Virgil C. Summer Nuclear Station (VCSNS) Units 2 and 3
Combined License Nos. NPF-93 and NPF-94
Docket Nos. 52-027 & 52-028

Subject: VCSNS Units 2 & 3 LAR 14-11: Request for License Amendment and
Exemption: Debris Screen Related Dimensions

Request for License Amendment:
Debris Screen Related Dimensions
(LAR 14-11)

Figure 1, Above Screen Location (Front View)

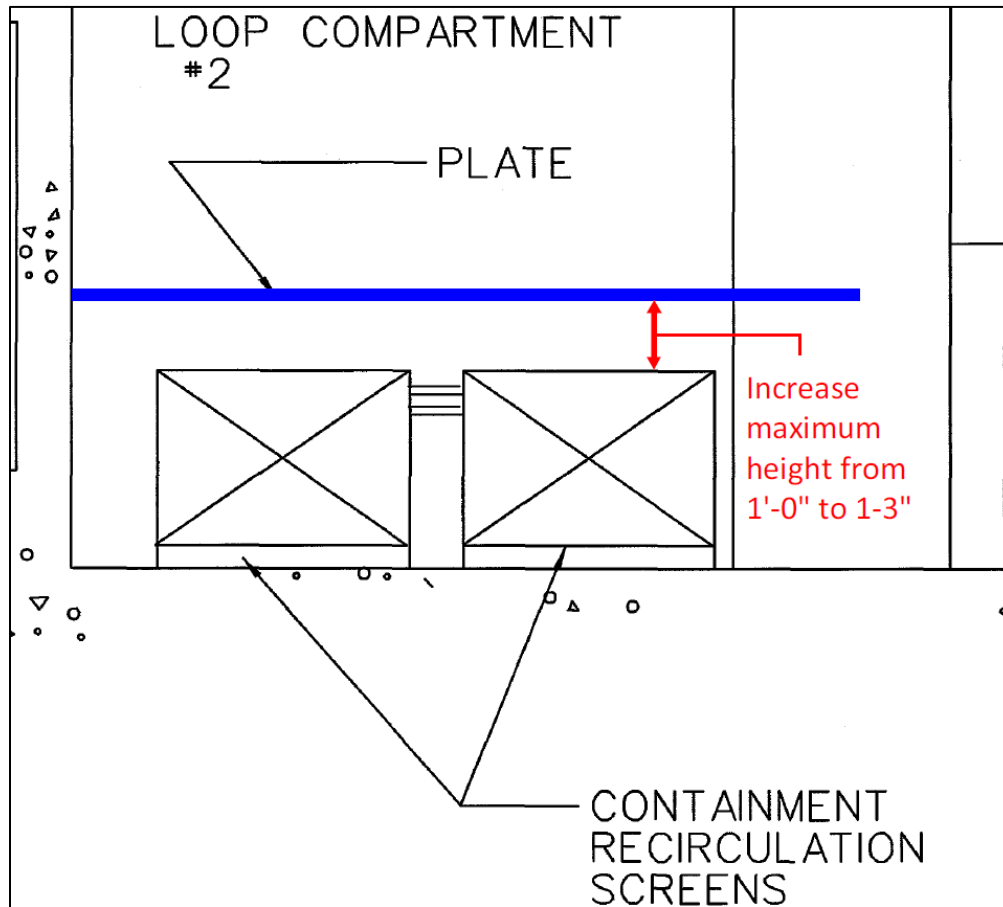
To address this inconsistency, it is proposed that the maximum distance of the plate above the top of the screen be increased to a height of 1 ft 3 in as shown in Figure 1 below. Note that this height requirement applies only at the required distances perpendicular to and to the side of the screens, as the corresponding debris transport evaluation, discussed further below, credits the height of the plate at these locations only. Changes are proposed to UFSAR subsection 6.3.2.2.7.1 to clarify this requirement. As discussed below in the technical evaluation that assesses the effect of this change on debris transport, this increased spacing does not adversely affect the design function of the protective plate, and thus continues to support acceptable screen performance.

Figure 2, Plate Extension Length (Top View)

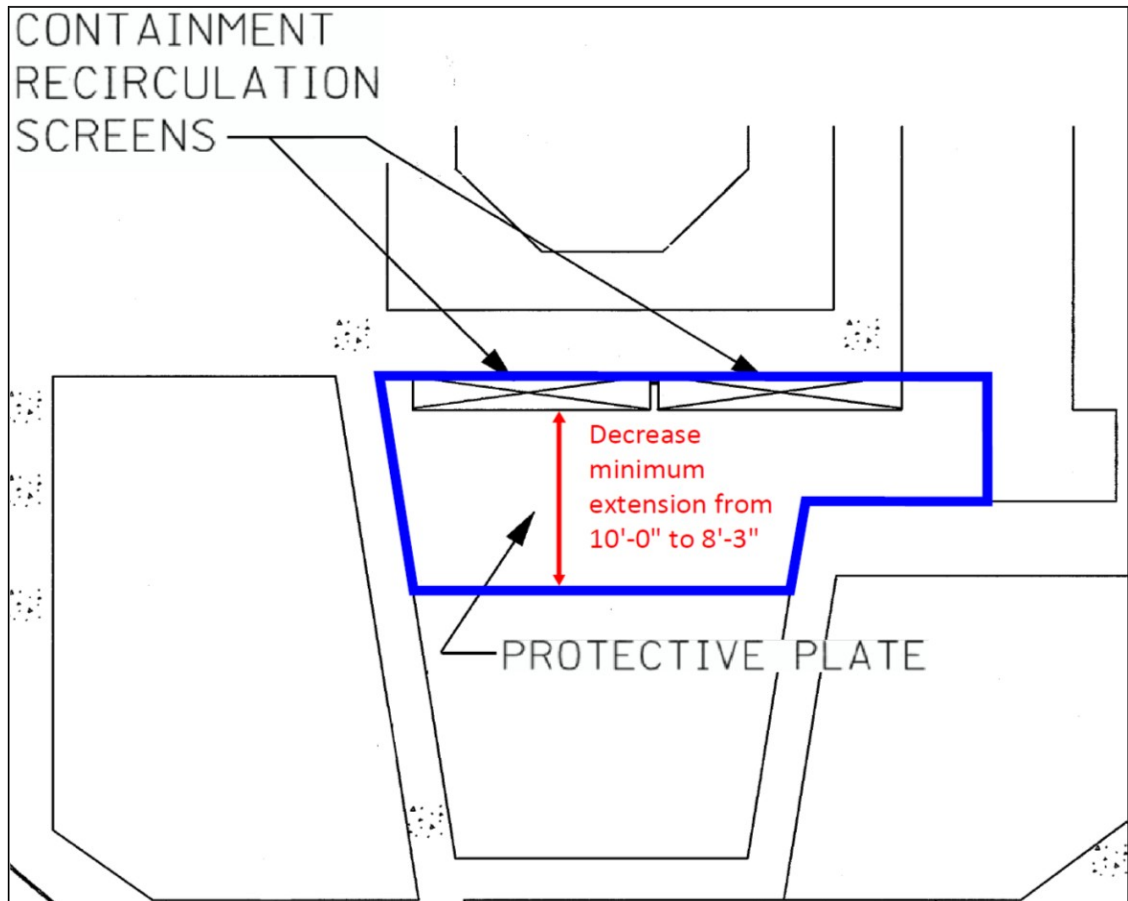
Additionally, it is proposed that the perpendicular extension of the plate beyond the recirculation screens be reduced from 10 feet to 8 feet, 3 inches as shown in Figure 2 below. This reduction increases clearance to support reactor coolant pump (RCP) removal and increases the accessibility for future maintenance. The proposed dimension changes affect COL Appendix C, plant-specific Tier 1, and the UFSAR identified minimum plate extension length from the front of the CR screens. The necessary licensing basis document changes are described in Table 3 below. As discussed below in the technical evaluation that assesses the effect of the change on debris transport, this reduction in plate length does not adversely affect the design function of the protective plate, and thus continues to support acceptable screen performance.
